Addendum No. 2
October 16, 2023

Project: **Harrisburg South Middle School Theatre Addition**
Harrisburg, South Dakota
Architecture Incorporated Project #3024

Scope of this Addendum:

CIVIL GRADING PLAN

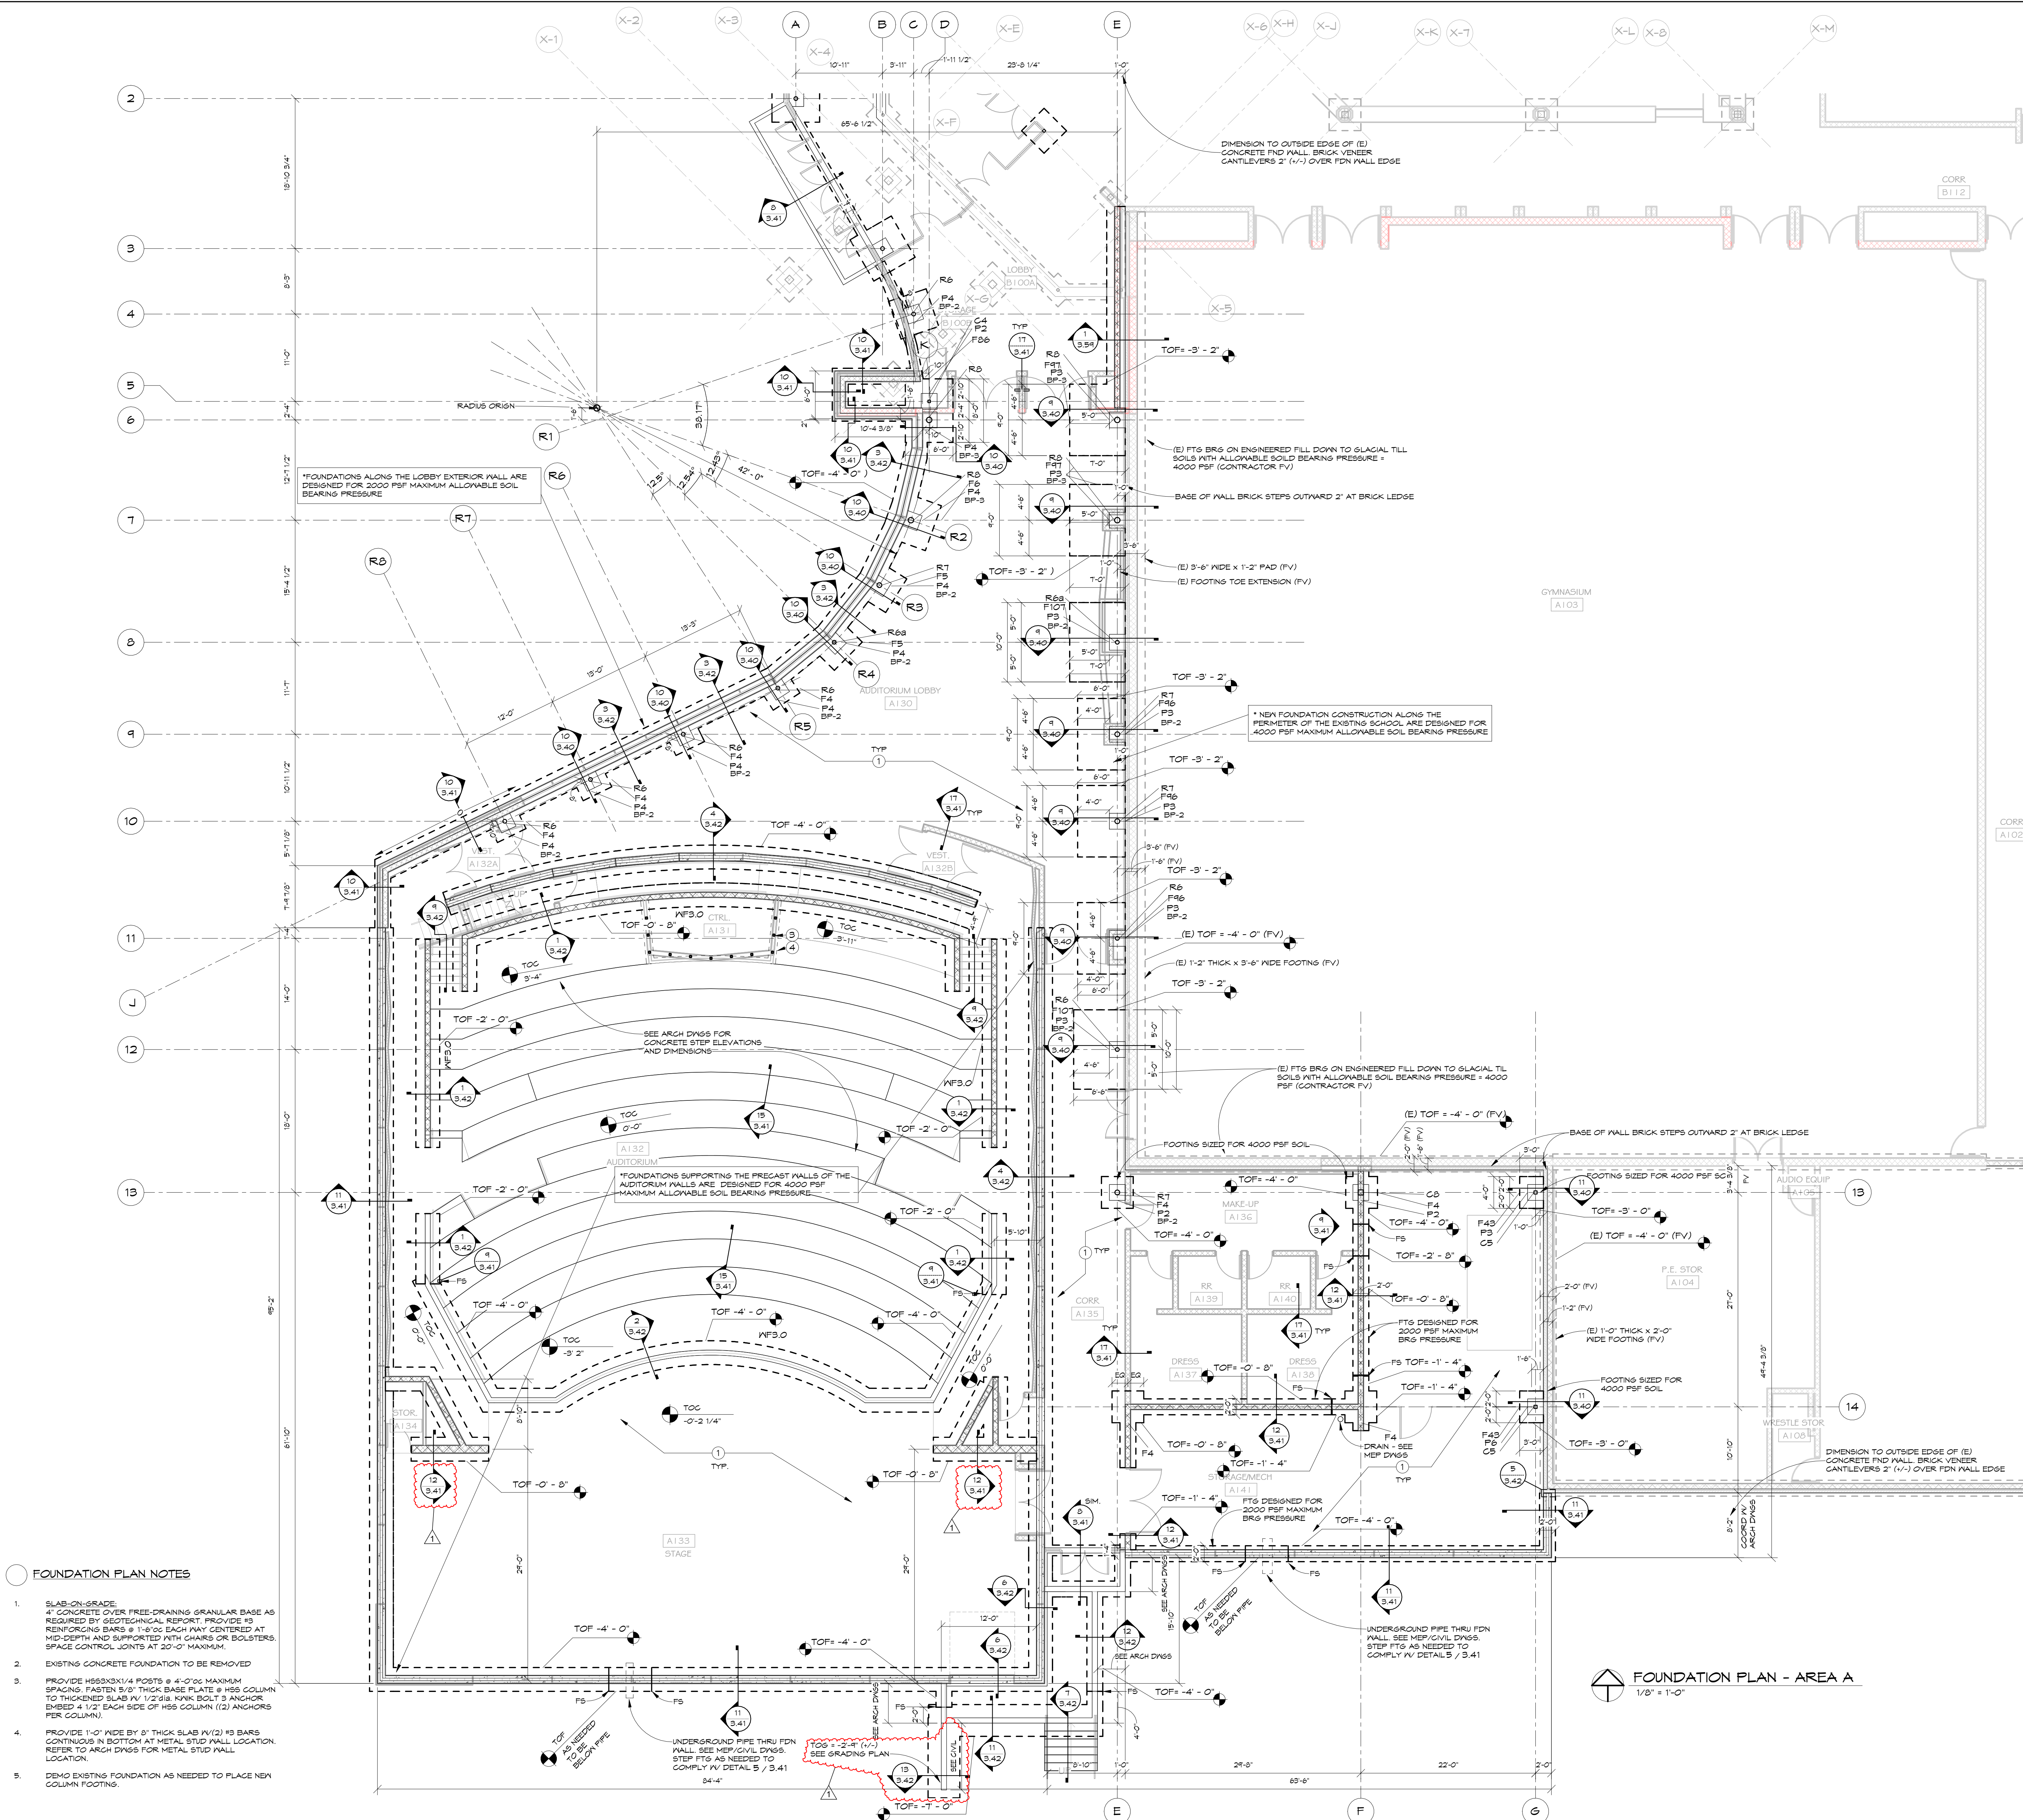
- a) See attached revised drawing 2.40 with revision date of 10-16-23 for clarification on spot elevations (clouded) adjacent to the loading dock area on the south side of the theatre addition.
